# WATER QUALITY MEMORANDUM

Utah Coal Regulatory Program

RE: 2009 Third Quarter Water Monitoring, Genwal Resources, Inc., Crandall Canyon Mine, Permit & Tracking #3377

*Iron Staining Visible in Crandall Creek Drainage at Outfall 002*

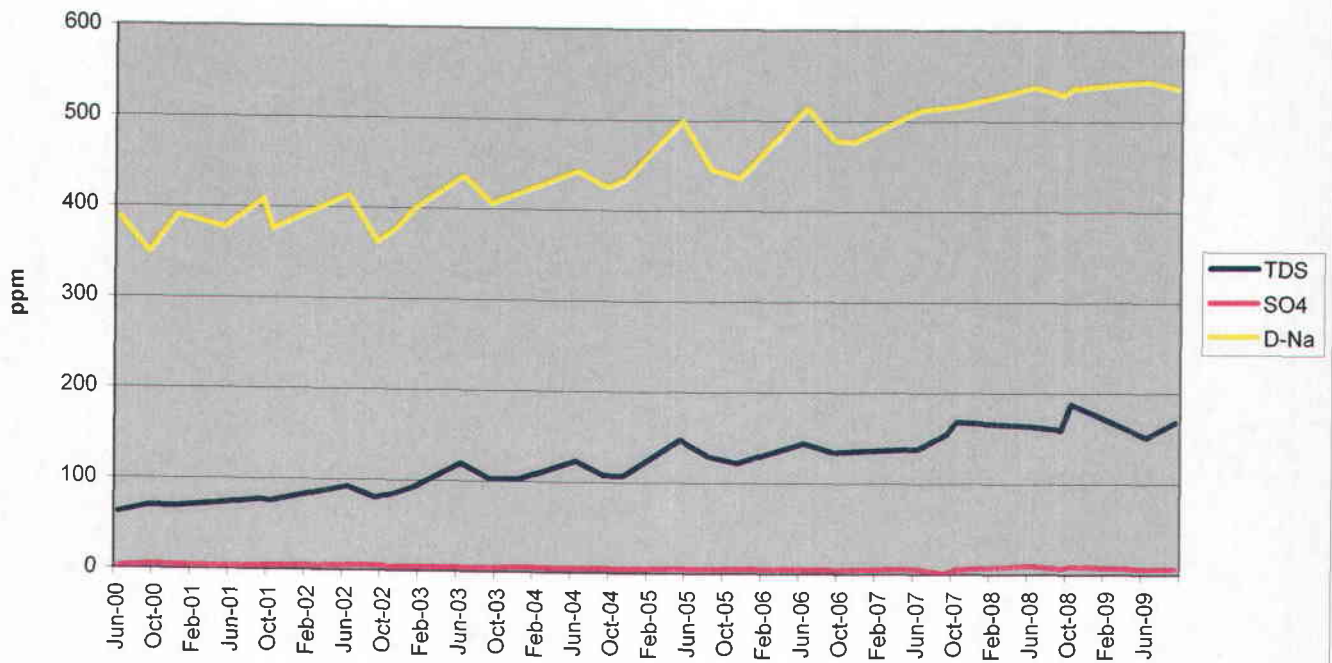
In addition, the stream channel of Crandall Creek has begun to show significant evidence of iron staining. The Division issued a Notice of Violation (NOV #10043) on August 10<sup>th</sup>, 2009 for failure to minimize disturbance to the hydrologic balance. DWQ issued a Narrative Standard Violation on August 10<sup>th</sup>, 2009 as well for the iron staining now evidence in the Crandall Creek stream channel.

Work with other regulatory agencies in determining what if anything can be done to remove or mitigate the iron staining within the Crandall Creek stream channel (See Photos Below).

## Crandall Creek Lower Flume (LOF-1): Total Iron Levels

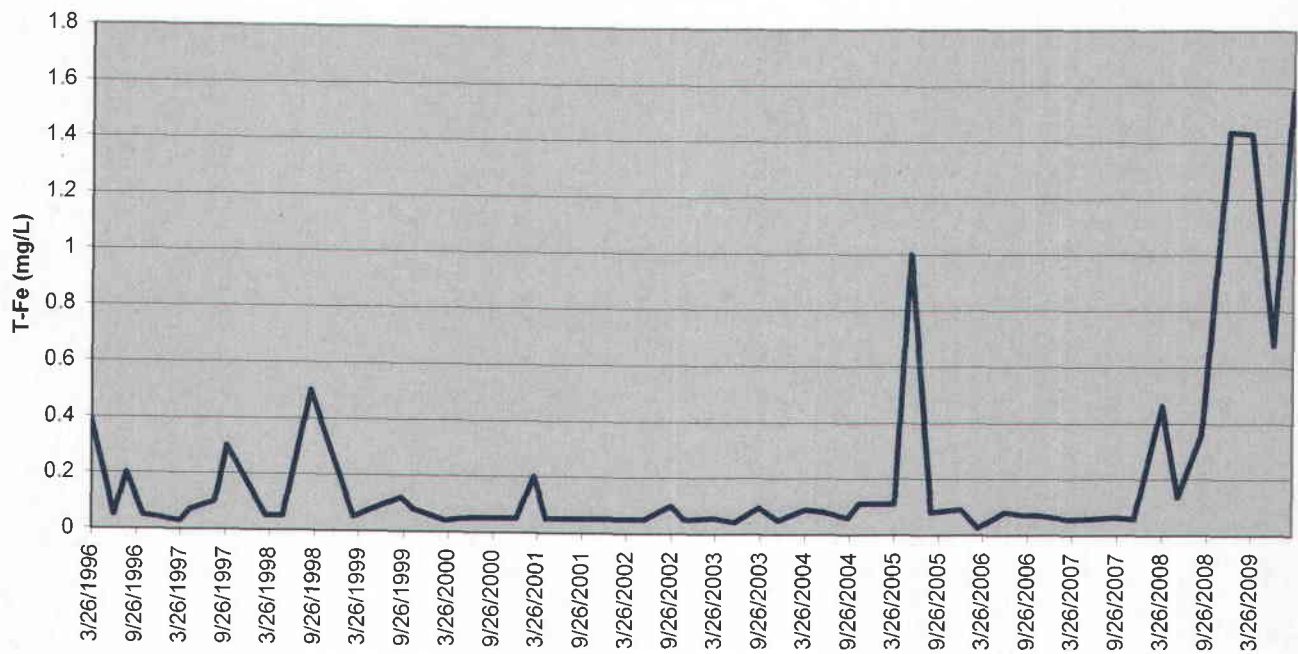
T-Fe levels measured below the mine facilities within the Crandall Creek drainage (Site LOF-1) rose significantly from the prior quarter continuing a weak upward trend that began during the 4<sup>th</sup> quarter of 2008 and 1<sup>st</sup> quarter of 2009 (1.438 ppm and 1.432 ppm respectively). The 2<sup>nd</sup> quarter of 2009 produced a T-Fe level of 0.679 at Site LOF-1. However, this quarter's results rose to 1.585 ppm. It would appear that the lower value obtained during the 2<sup>nd</sup> quarter of this year may have been an anomaly.

Maintain a close examination of T-Fe values within the Crandall Creek drainage (specifically surface water monitoring site LOF-1).

**Total Iron (T-Fe): Outfall 002**

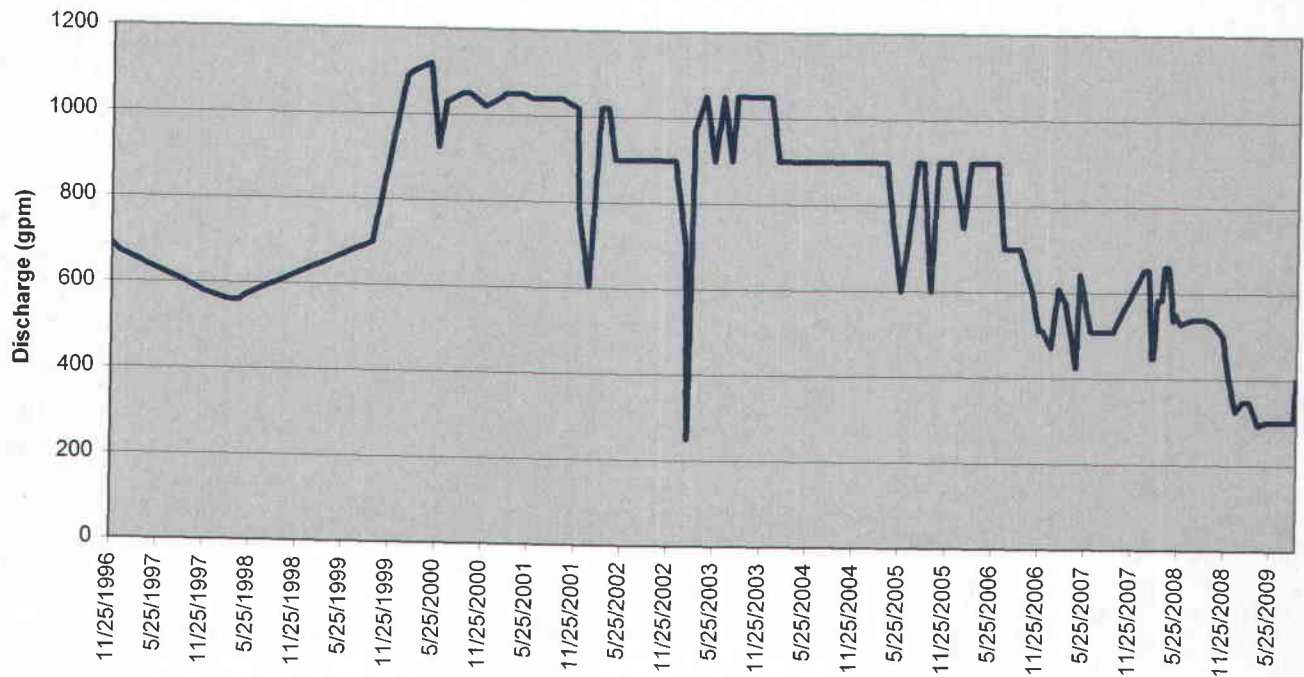
The 3<sup>rd</sup> quarter of 2009 produced analytical data from Outfall 002 that follows the same trend as has been established in the last 4 consecutive quarters. TDS levels from three sampling events remained below compliance levels (743 ppm, 696 ppm and 707 ppm respectively). Conversely, T-Fe levels obtained from the three sampling events were all above the UPDES compliance level of 1 ppm (2.501 ppm, 2.331 ppm and 2.455 ppm).

Continue to work with the Permittee in identifying a mine-water treatment system that will effectively lower the T-Fe concentrations to compliant UPDES levels.
